June 30, 2023

Los Gatos Planning Commission  
110 E. Main Street  
Los Gatos, CA 95030

RE: Neighbor Response to Proposed 2-Story House Construction at 232 Danville Dr., Los Gatos, Ca. 95032.

Fig 1. Evening picture taken from the street (Pinehurst Ave.) a block away over rear neighbor's house

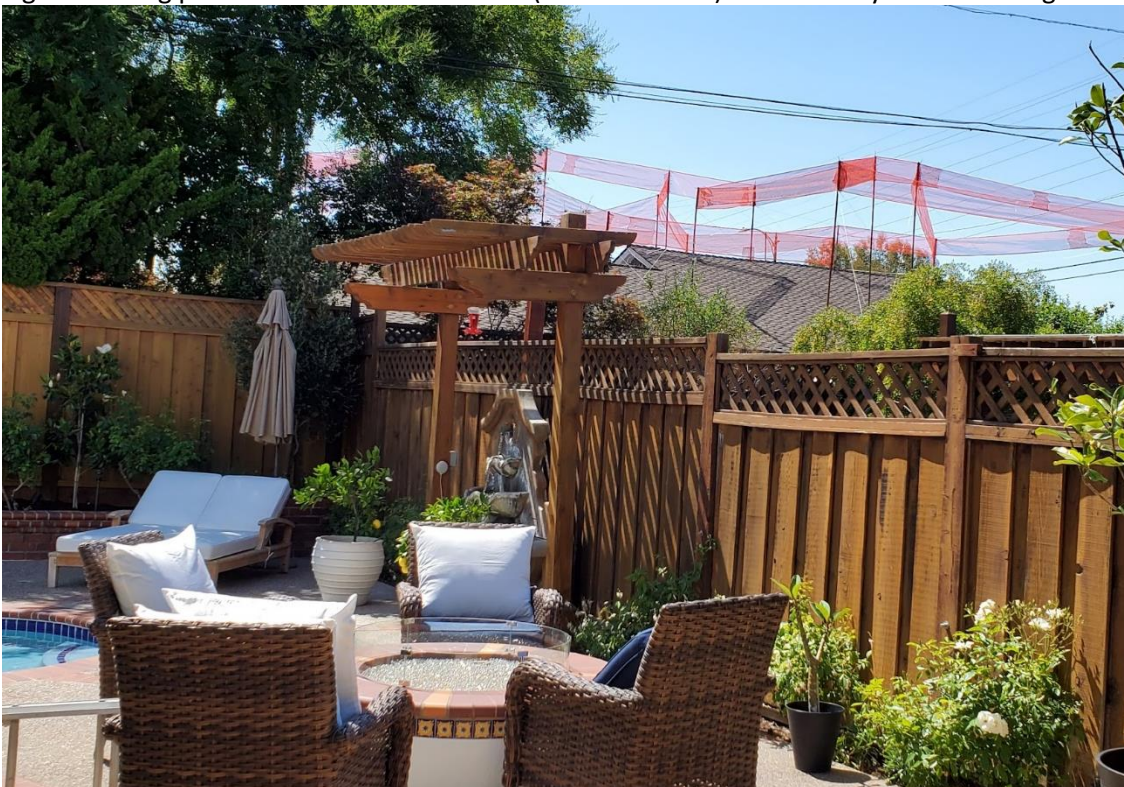
- The height of the structure is ~ 17% greater than the majority of other 2-story homes in the neighborhood, adding to privacy issues, difficulty in masking structure with and visual mass impact. Is it possible to bring it more inline?

- The general massing and visual bulk, as observed from properties to the rear, appears overpowering the area, given lots typically of 8000 SF and small rear setback, which makes the structure's size out of place for the neighborhood. Are there architectural changes that can improve this?

Fig 2. View from backyard of rear and side of proposed 2-story house

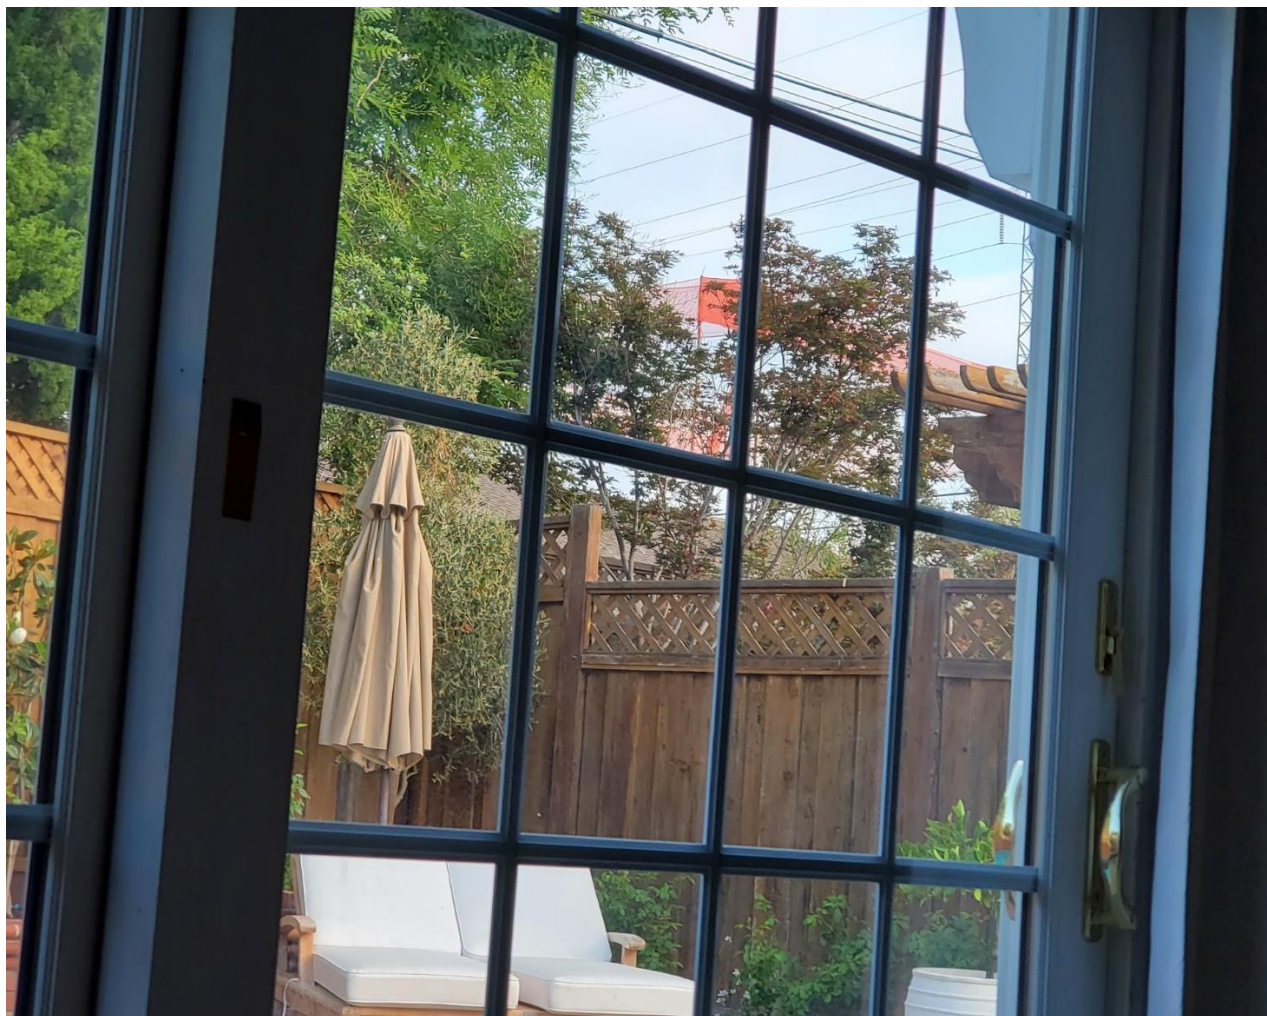
- The 2<sup>nd</sup> level rear facing windows of Master Bedroom and Master Bath present a two-way privacy issue given the proposed home's height, setback, and proximity to rear neighbor yards and houses. It's not clear exactly how high trees would need to be to provide privacy screening. My sideyard patio and firepit area is fully exposed along with partial exposure of backyard pool area/deck. My property's downstairs bedroom with sliding door to the pool area is exposed - I can see the proposed location of the 2<sup>nd</sup>-story master bedroom and master bathroom windows from the bed. Based on angle, I would be peering across the master bath's freestanding tub and into the master bath shower. At least glass that obscures the view (e.g. glass block) into the master bathroom should be used.

1. Use a glass that obscures the view (e.g. glass block) into the master bathroom.
2. Because of the project's large structure and the height of 2<sup>nd</sup> story windows, landscaping should include evergreen privacy trees of reasonable initial maturity to soften the structure's visual affect and provide a level of privacy to all neighbors, not only the 2 on each side and 1 directly to the rear.
